Re: Bray to City Centre Core Bus Corridor Scheme Compulsory Purchase Order 2023
Bray to Dublin City Centre

**RE: SUBMISSION TO AN BORD PLEANÁLA REFERENCE: KA27.317780 BRAY TO CITY CENTRE
BUSCONNECTS BUS CORRIDOR SCHEME COMPULSORY PURCHASE ORDER.**

SUBMISSION REGARDING BUS CONNECTS DUBLIN CPO ON BEHALF OF CIRCLE K BRAY SERVICE STATION	
Project Title:	BusConnects Dublin: Bray to City Centre Scheme CPO
Author:	Mr. Conor O Brien ME Eng. MIEI
Approved & Checked:	Mr. Brian Loughrey BE CEng. MIEI
Date:	02/10/2023
Subject:	Submission to An Bord Pleanála
MHL Document Ref:	23117TT-Doc01 R02

Observation on Strategic
Infrastructure Development
Bray to City Centre Core Bus
Corridor Scheme and
Associated Compulsory
Purchase Order 2023

Figure 7 – Circle K Bray, highlighting areas that are set to be subject of a temporary and permanent CPO (source: McArdle Doyle, 2023)

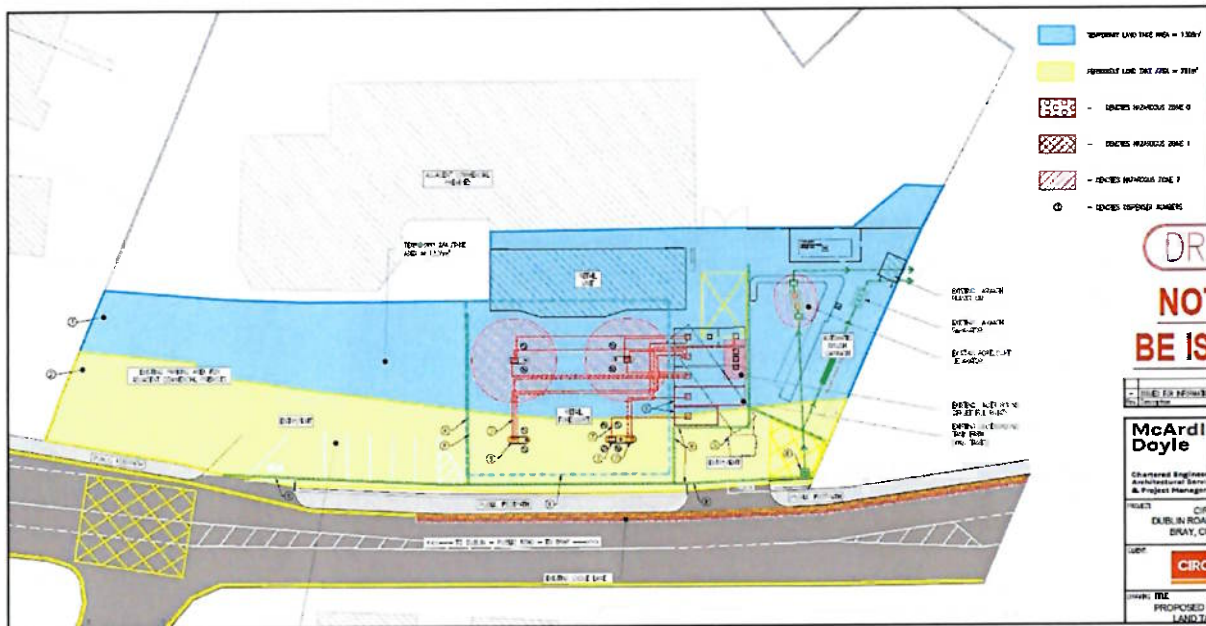
In making this observation, our clients wish to highlight their concerns with respect to the proposed works to the front of their property, in addition to the CPO acquisition of these lands.

As a result of the planned scheme, the loss of land both permanently and temporarily to accommodate the BusConnects route will have serious implications for the overall business and its future viability.

In the first instance, it is understood that the temporary acquisition of the service station is premised on the risk associated with works involving the removal of the fuel dispensers and underground petrol tanks and pipes. It is further understood that the entire station is to be temporarily acquired and decommissioned during the works and that these works are to be carried out by a competent contractor.

Secondly, it is understood that the scheme will result in the loss of approximately 5no. parking spaces at the service station. Given the very small size of the site, the loss of these spaces is likely to be permanent as no other appropriate space will be available to accommodate same. The loss of circulation space within the station site will also impact on parking availability and safe and effective access and egress at the station.

Figure 3: Proposed Cross Section of BusConnects Route in Vicinity of Property

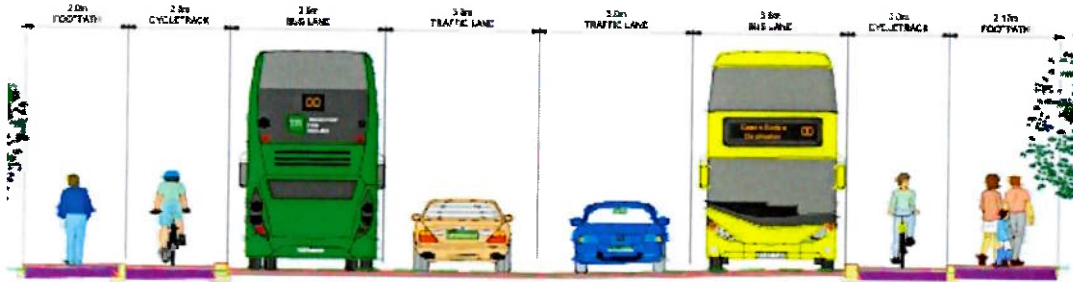
The proposed BusConnects Scheme at this location includes 2No. 3m wide bus lanes, 2No. 3m wide traffic lanes, 2No. 2m southbound cycle tracks and 2No. 2.0m footpaths. To accommodate this cross-section, it is proposed to set back the existing boundary of the service station by approximately 7.5-9.5m. This will impact on much of the existing infrastructure in the service station including the underground fuel tanks, three pumping stations, the existing car wash, the existing underground pipe network, the existing canopy over the forecourt and the existing display signage. The loss of this infrastructure will have extremely significant negative impacts on the operation of the business. Figure 3 below shows the proposed cross section of the scheme in the vicinity of the business while Figure 4 shows a plan view of the proposed scheme as it passes in front of the site.

Figure 5: Serve Map Extract showing Proposed CPO Areas

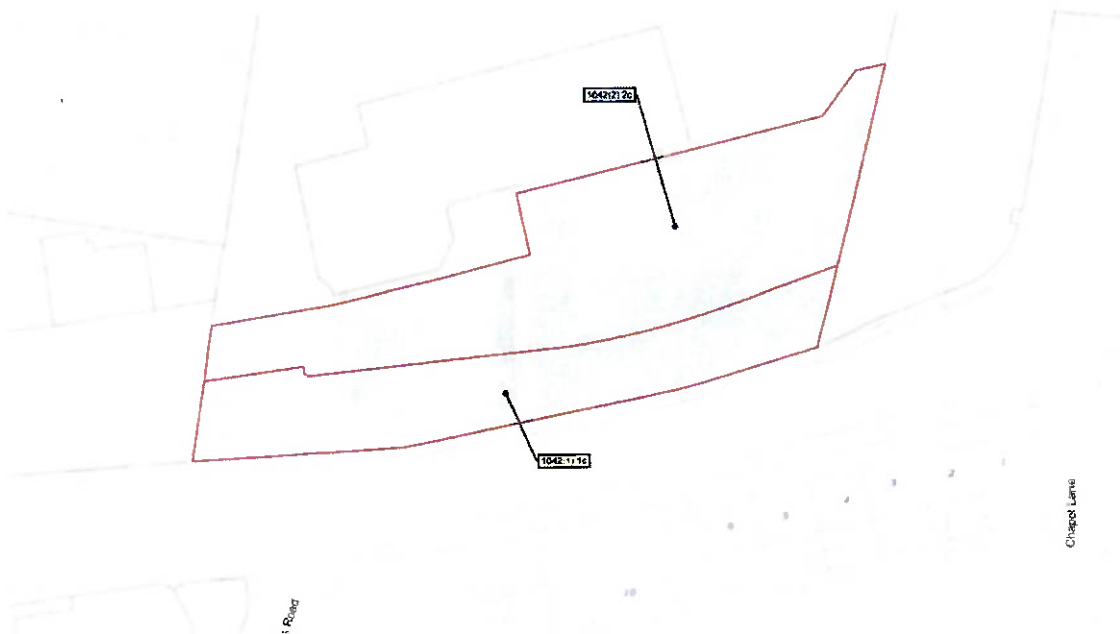
The following are a number of concerns our client has raised in relation to the published CPO associated with the Dublin BusConnects Bray to City Centre Scheme. The CPO seeks to permanently acquire a strip of land between 7.5m and 9.5m wide at the front of the property resulting in a total of 772.3m² area of land take. It is also proposed to temporarily acquire the entire service station site during the works, a total area of 1289.7 m² of land take. See Figure 5 below which shows an extract from the CPO Serve Map which was issued by the NTA to Circle K Ireland.

Figure 6: Proposed Access Arrangement

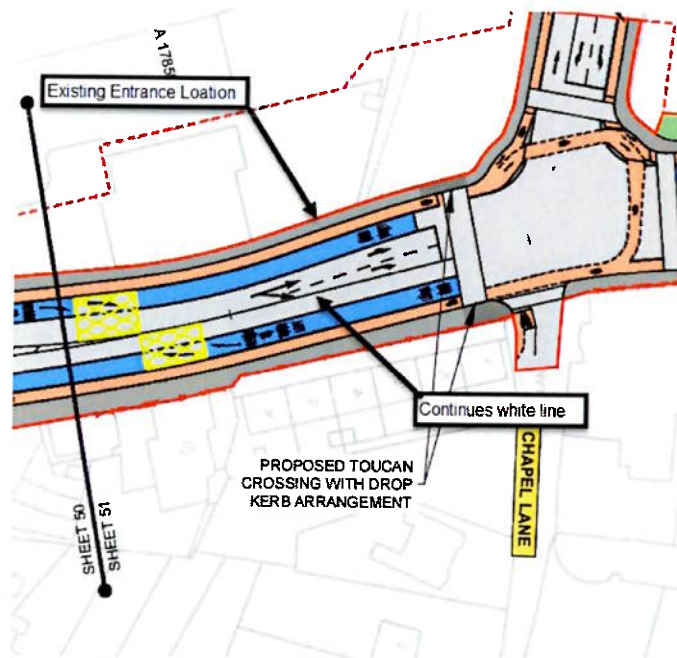
The service station site currently benefits from 2 number entrance/exit points along the Dublin Road, one of which is shared with Bright Ford, Bray car showrooms. These entrances are integral to the operation of the business as it allows vehicles to enter in one side of the site and exit through the other side. This removes the requirement for vehicles to turn in the forecourt where space is limited. It is also a requirement for the fuel tanker making deliveries to the site to use both entrances as there is no space for a vehicle of that size to turn within the site.

The current road layout also allows for the right turn movement for northbound vehicles into the site at one of the entrances. It is not clear whether this movement is retained in the proposed layout. A continuous white line is shown in the centre of the road meaning vehicles cannot cross from the northbound lane into the service station. The proposed access arrangement can be seen in Figure 6 below. If this right turn movement is not retained, it will have a significant negative impact on the operation of the service station business. A large proportion of business will be lost as northbound traffic will not be able to use the service station. There are also no yellow box road

markings shown at the entrances meaning traffic will queue across the junction blocking traffic from entering and existing the site.

The existing entrances to the service station are not marked on the proposed layout drawings and thus it is unclear how they will operate in the future. The entrance arrangements should be clearly marked on the drawing in order to show how they will integrate with the proposed design. It is also unclear if the proposed bus stop on front of the car showroom will partially or fully obstruct the entrance to the service station in its current location.

Figure 6: Proposed Bus Stop

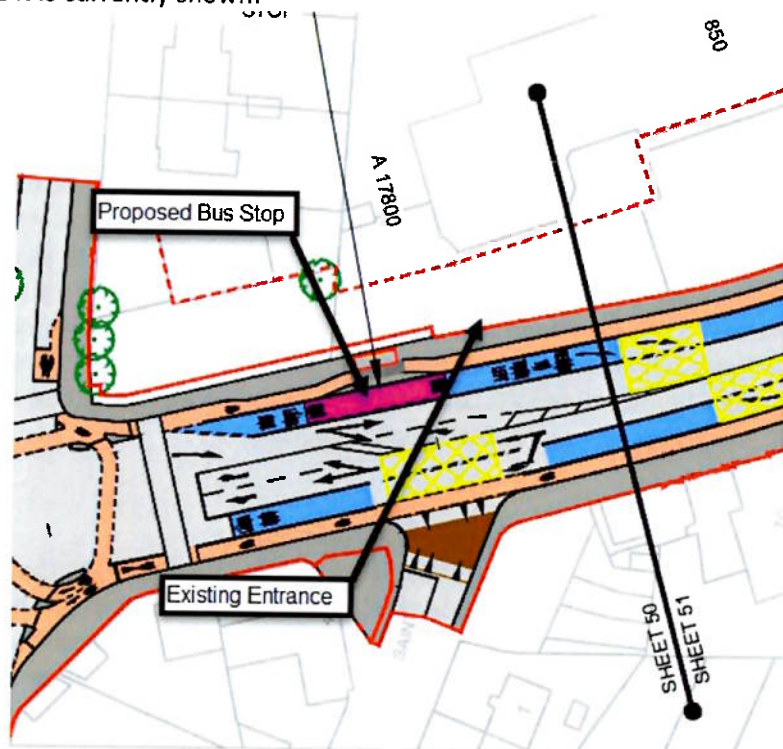
It is proposed to relocate one of the bus stops along the Dublin Road in very close proximity to one of the entrances to the service station. When this bus stop is in use the sightlines from this junction will be impeded by the bus. This could lead to collisions between vehicles exiting the service station and southbound traffic on the road. This is a serious safety concern with the proposed layout. 49m uninterrupted sightlines should be provided at priority junctions for a design speed of 50 km/hr in accordance with DMURS. This will not be achieved if the proposed bus stop is constructed in the location where it is currently shown.
